## HISTORIC AND DESIGN REVIEW COMMISSION

**HDRC CASE NO:** 2016-071  
**ADDRESS:** 901 E HOUSTON ST  
**LEGAL DESCRIPTION:** NCB 164 BLK LOT 4 EXC W TRI 15.47 FT  
**ZONING:** D HS VP-1  
**CITY COUNCIL DIST.:** 1  
**LANDMARK:** Gillespie Ford / Bimbi Shoes  
**APPLICANT:** Greg Shue/Open Studio Architecture  
**OWNER:** Baywood Hotels  
**TYPE OF WORK:** Addition, rehabilitation and signage  
**REQUEST:**

**Historic and Design Review Commission  
Design Review Committee  
Report & Recommendation**

HDRC Case# 2016-071

## SCHEMATIC PERSPECTIVE

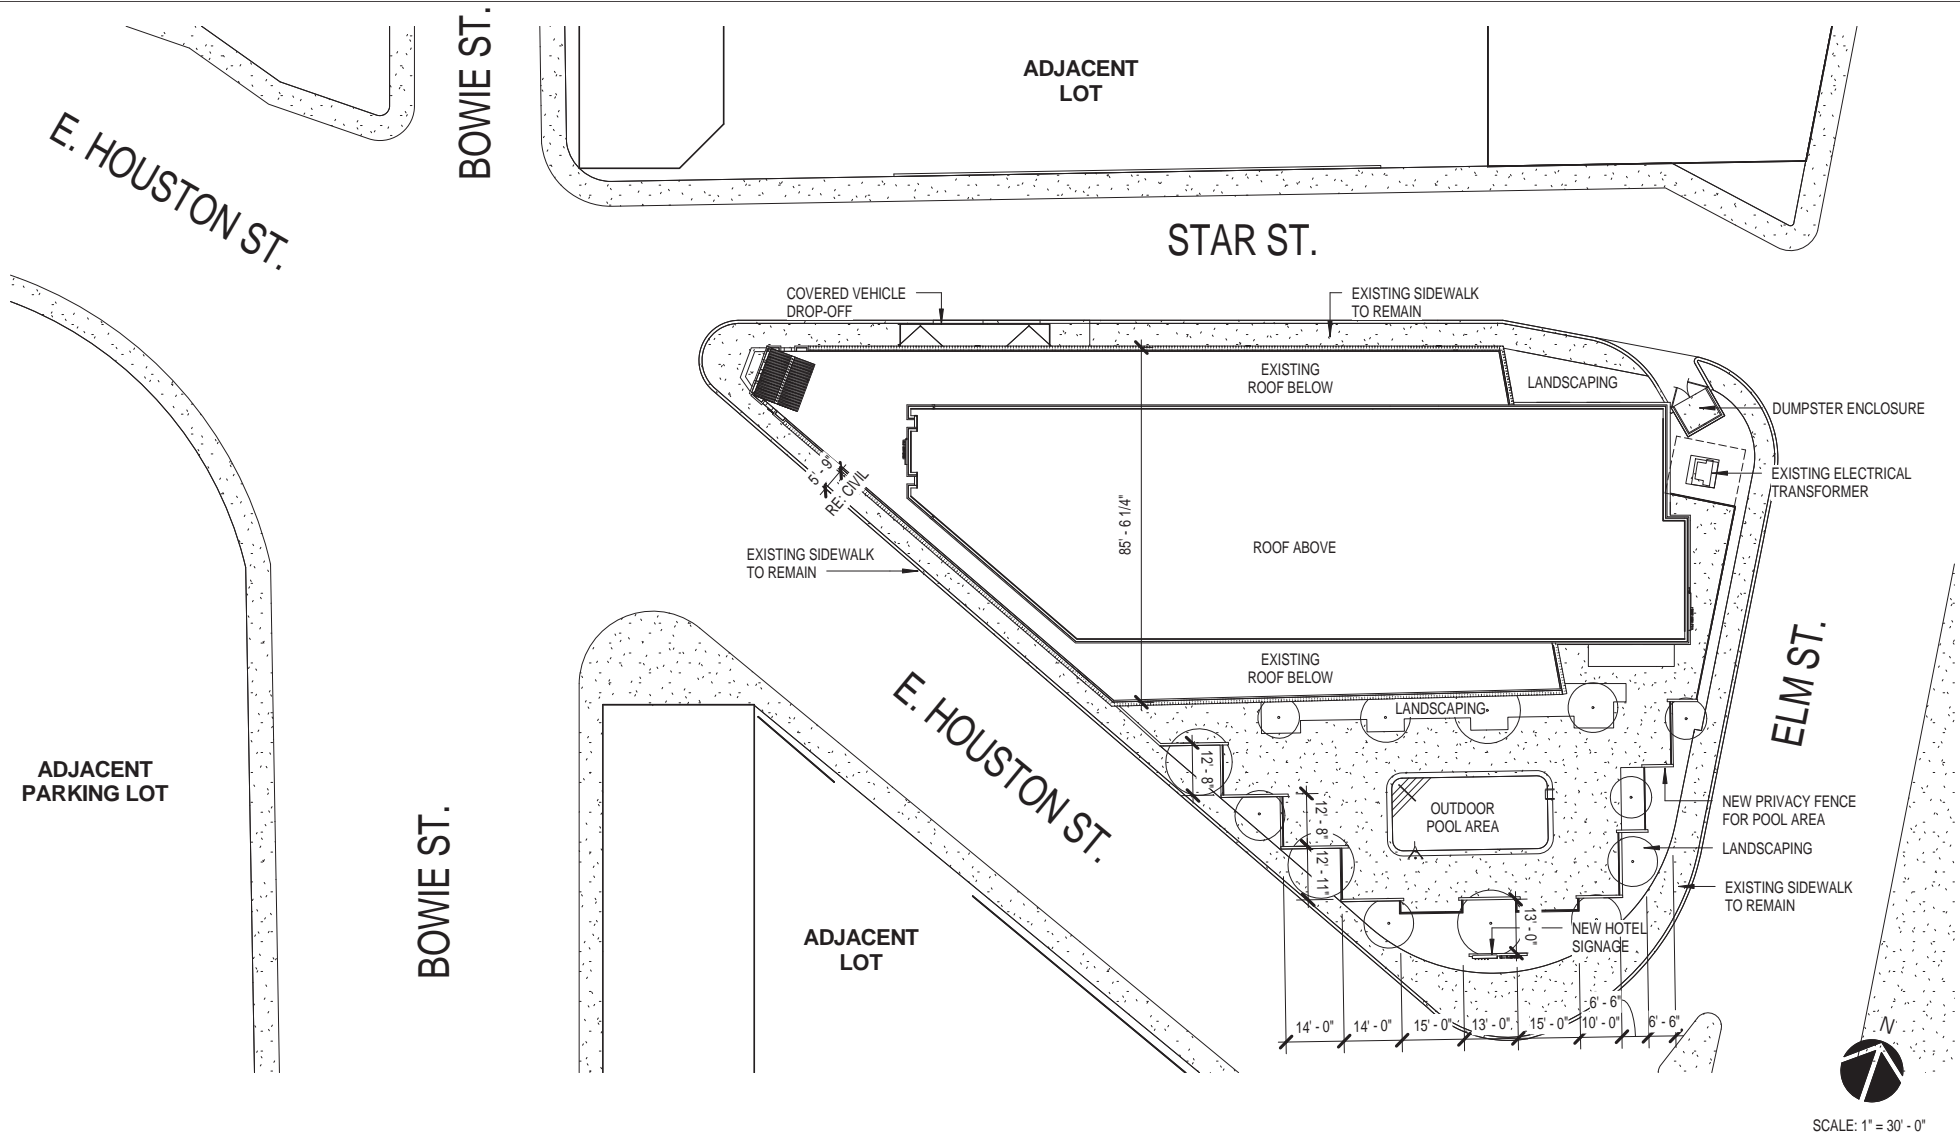
DL: PROVIDE AN UPDATED COLOR RENDERING WITH UPDATED COLOR SCHEME.

## SCHEMATIC ELEVATION

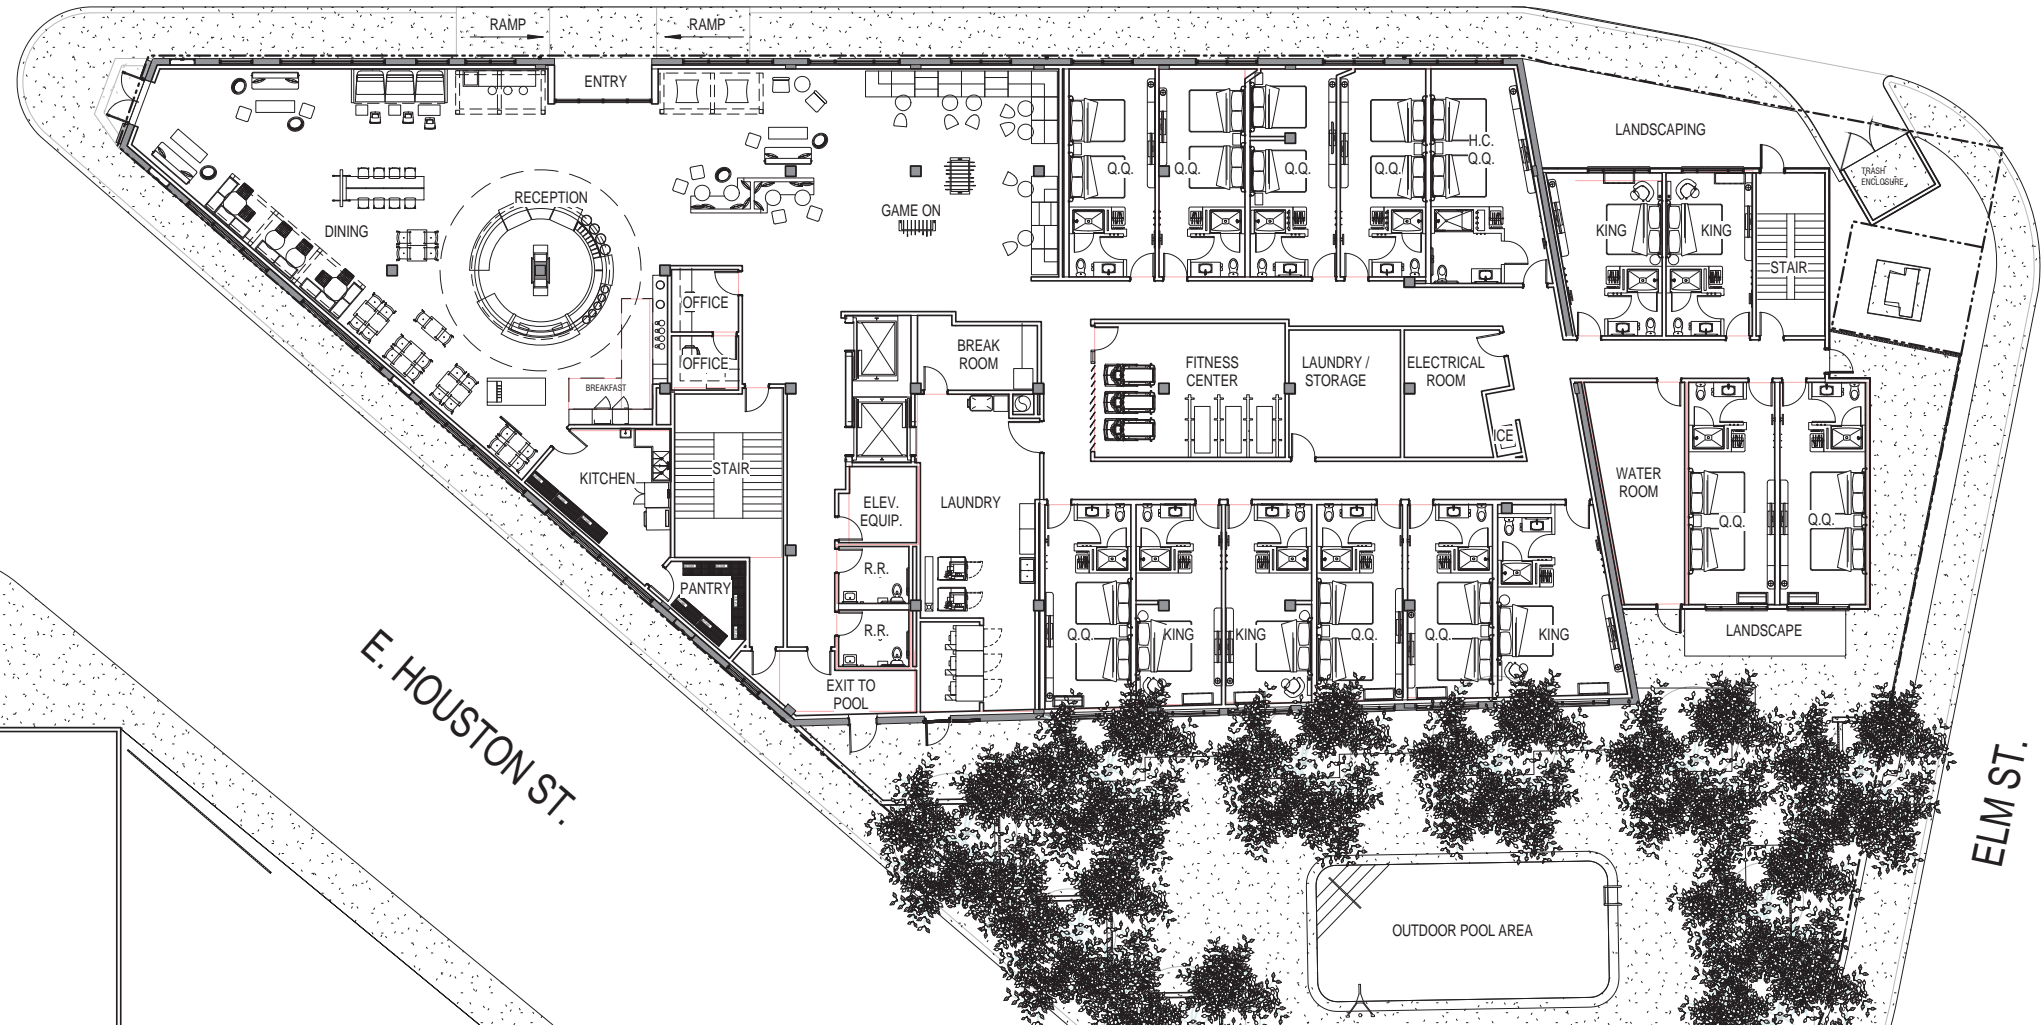
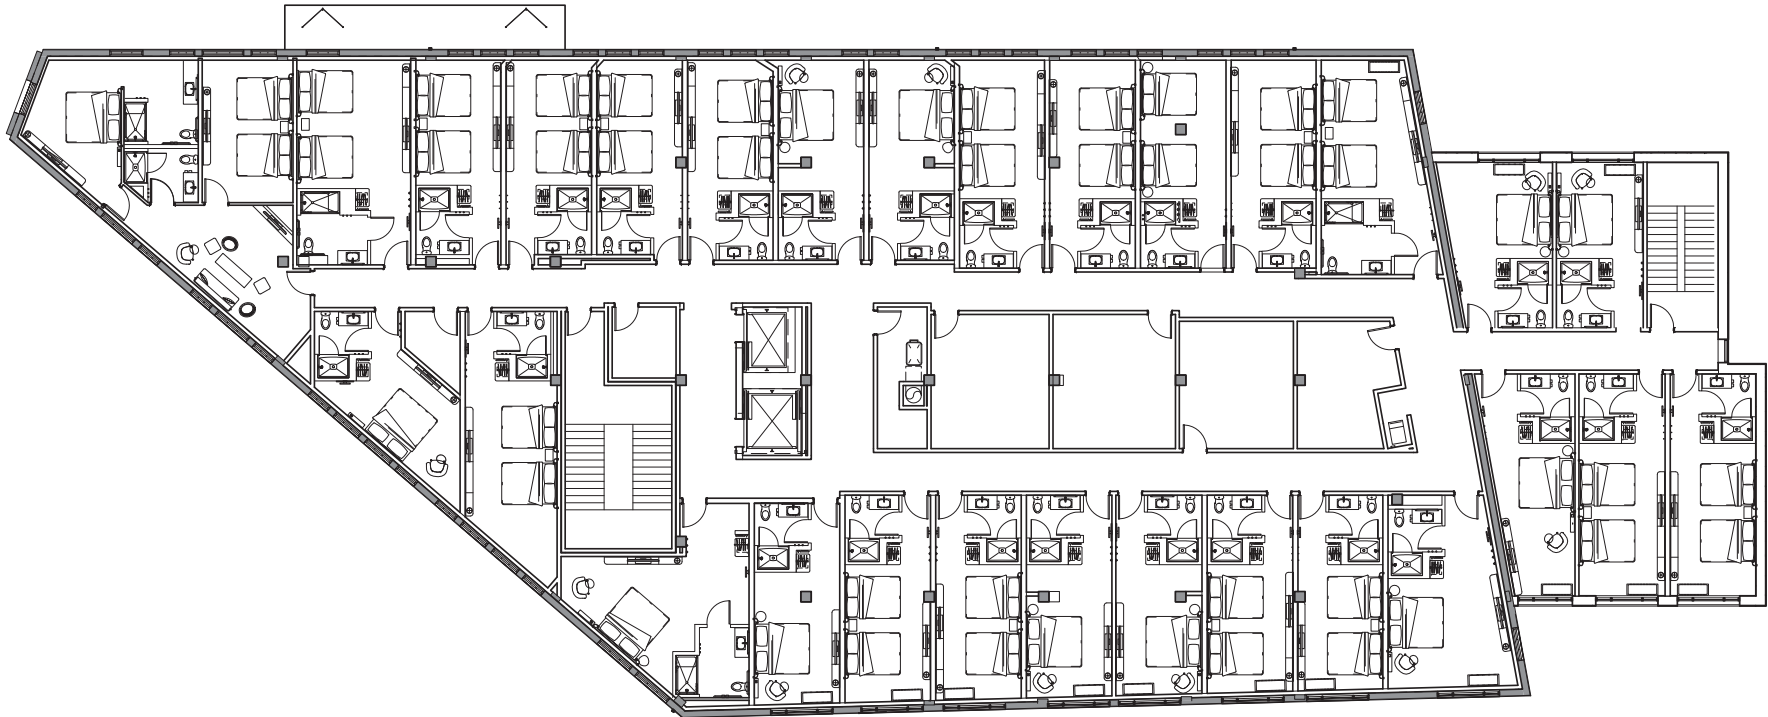
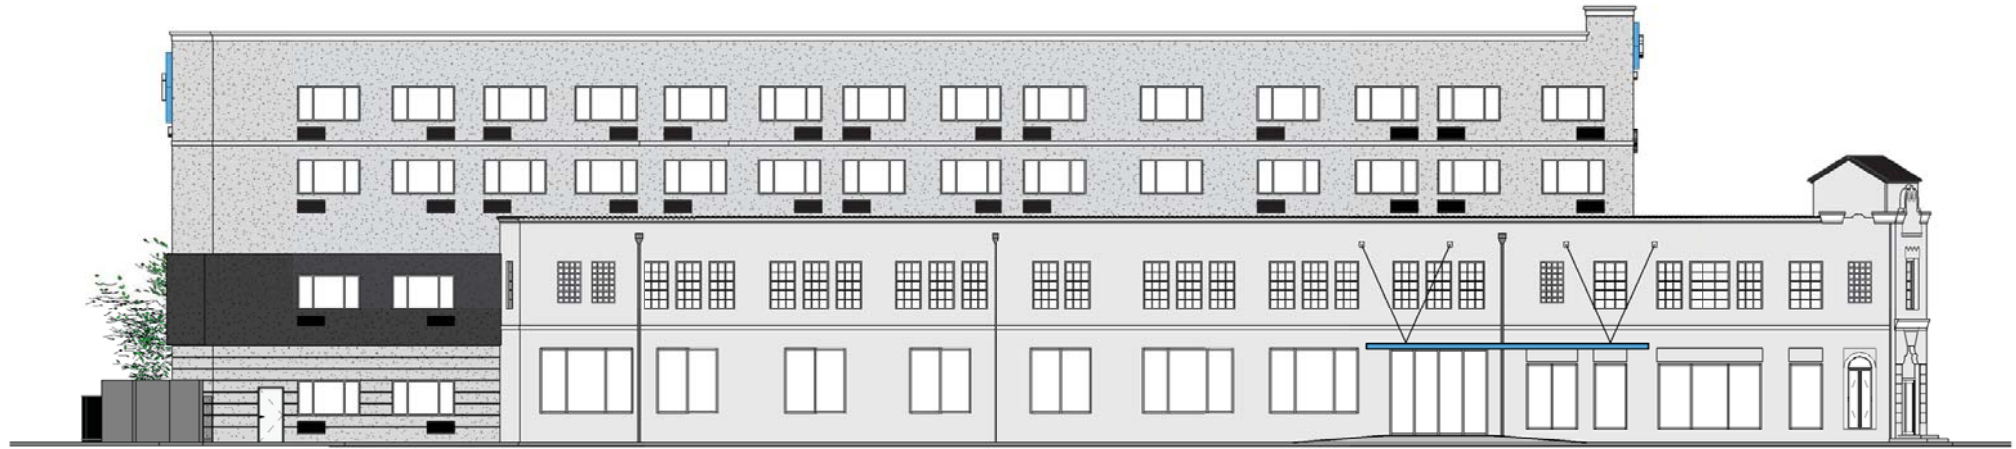
- u. Facing east toward Elm Street and IH-37, the applicant has proposed a more contemporary approach to the addition's façade arrangement. This façade is to feature a first level façade consisting solely of metal panels, a second level façade consisting of dark gray stucco and facades of window openings, lighter gray stucco and metal panels for the third and fourth levels. On the southeast side of the rear façade, the applicant has proposed to place signage. Staff finds that the proposed materials and signage placement are appropriate, however, staff finds that the applicant should continue explore ways to introduce additional façade separation and fenestration to the rear façade.

DL: REAR / E HOUSTON FACADE SEEMS "FLAT"; NEED SOME REVISION.

MG: COULD WINDOWS CONTAIN A VERTICAL ORIENTATION INSTEAD OF A PRIMARILY HORIZONTAL ORIENTATION. -- POTENTIALLY OFFSETTING OR ADDING FALSE ELEMENTS TO MAINTAIN WINDOW PATTERNS IN VOID SPACES; SIMILAR TO APPLICATION ON ORIGINAL STRUCTURE.

DL: HORIZONTAL BANDING QUESTIONS... FINISH OR LAP TO BUILDING.

REVISE ELEVATIONS, RENDERING PER COMMENTS
